BRT_AN_019

FT90x Revision B to Revision C - Migration Guide

Version 1.1

Issue Date: 2017-11-01

Figure 5.1 – Power Circuit Suggestion for Compatibility with Revision B and C

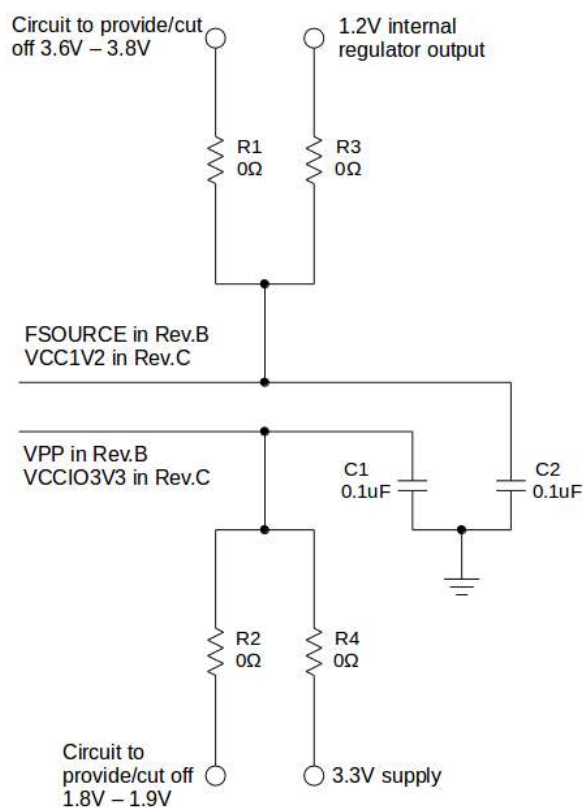
The FT90x Revision C chips have 3 pins which require different voltages compared to Revision B, namely FSOURCE, VPP and VBAT. This section suggests an approach to board design so that both Revision B and C chips can be used.

FSOURCE and VPP in FT90x Revision C are re-named as VCC1V2 and VCCIO3V3 to indicate their voltage requirement (refer to the FT900/1/2/3 and FT905/6/7/8 Revision C datasheets, which can be accessed via [Appendix A](#) below). These requirements differ from Revision B, so a PCB that supports both revisions must take care to provide to correct voltages to the currently used IC. A suggestion is as follows:

When Revision B is used, leave R3, R4, C1 and C2 unconnected. When Revision C is used, leave R1 and R2 unconnected. Note that if EFUSE programming is not required in Revision B, FSOURCE and VPP should be floating, which means R1 and R2 are not needed as well.
